Model: S-C3				ate: 16-Ma	r-07	No.: MB872001			
Modified Article: ADF parts change for paper slipping noise Prepared by:Y.Yoshida									
From: 1st Tech. Su									
Reason for	Parts catalog correction	☐ Vendor	cha	ange	Other				
Modification:	To fooilitate accombine M To income		ove reliability			et standards			
	☐ Part standardization	☐ Product Safety		afety	(RoHs	compliant)

Modification Bulletin

Model: Stella-C3 ARDF (DF1000) Date:27	7-Jun-07 N o.: MB872002a
--	---------------------------------

Model: Stella-C3 ARDF (DF1000)

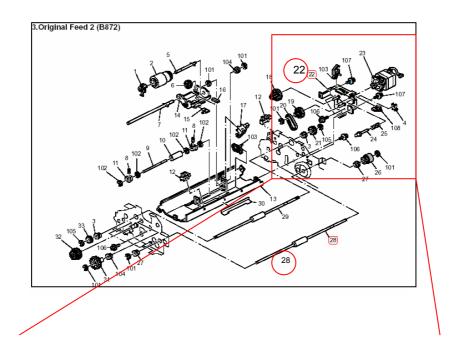
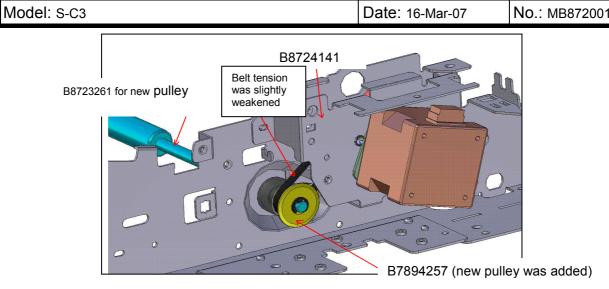
Change:

1) The shapes of the reverse drive roller and motor bracket were changed.

2) A flange pulley was added.

Reason: To improve the tension of the belt.

Note: This prevents the paper from slipping during switchback (and making a slipping noise). See RTB B872001.

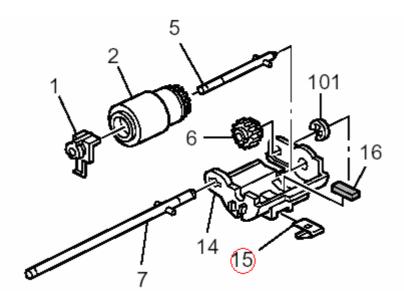
Change: The thickness of the spring plate was reduced from 0.2 mm to 0.15 mm (which

reduces the spring pressure).

Reason: To further ensure that multi-feeds do not occur.

Difference between the old and new parts: The new part has two small holes. This MB will be reissued later to announce the cut-in serial numbers for this change.

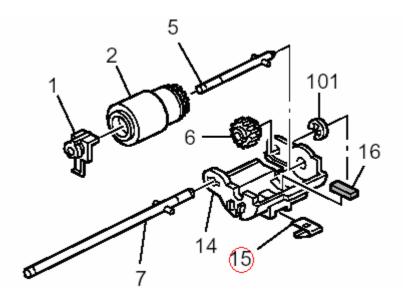
Change: The thickness of the spring plate was reduced from 0.2mm to 0.15mm (which

reduces the spring pressure).

Reason: To further ensure that multi-feeds do not occur.

- Difference between the old and new parts: The new part has two small holes.

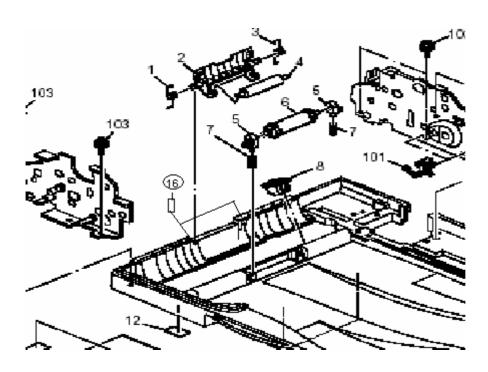
Change: Two Mylars (Guide: Base: Driven) were added to the ARDF base frame.

Reason: To ensure that originals curled at the leading edge do not jam.

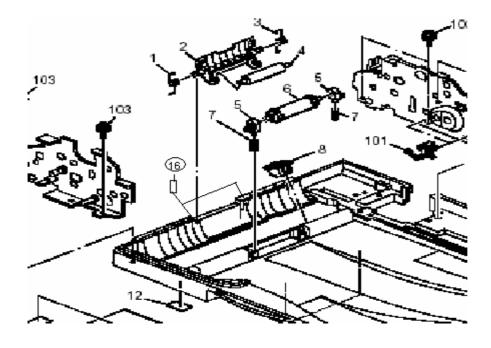
Change: Two Mylars (Guide: Base: Driven) were added to the ARDF base frame.

Reason: To ensure that originals curled at the leading edge do not jam.

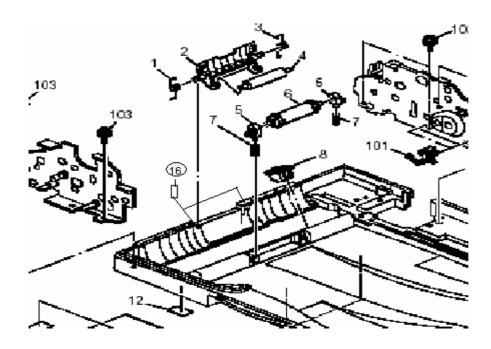
Change: Two Mylars (Guide: Base: Driven) were added to the ARDF base frame.

Reason: To ensure that originals curled at the leading edge do not jam.

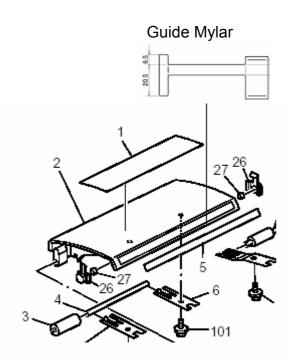
Change/Reason: The following part was missing from the parts catalog.

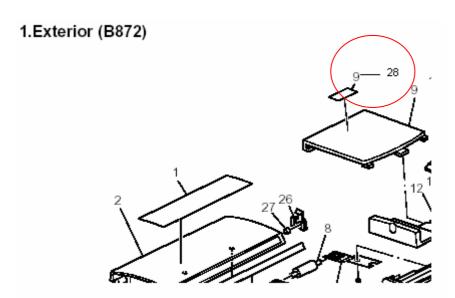
Incorrect Index number: 9 Correct Index number: 28
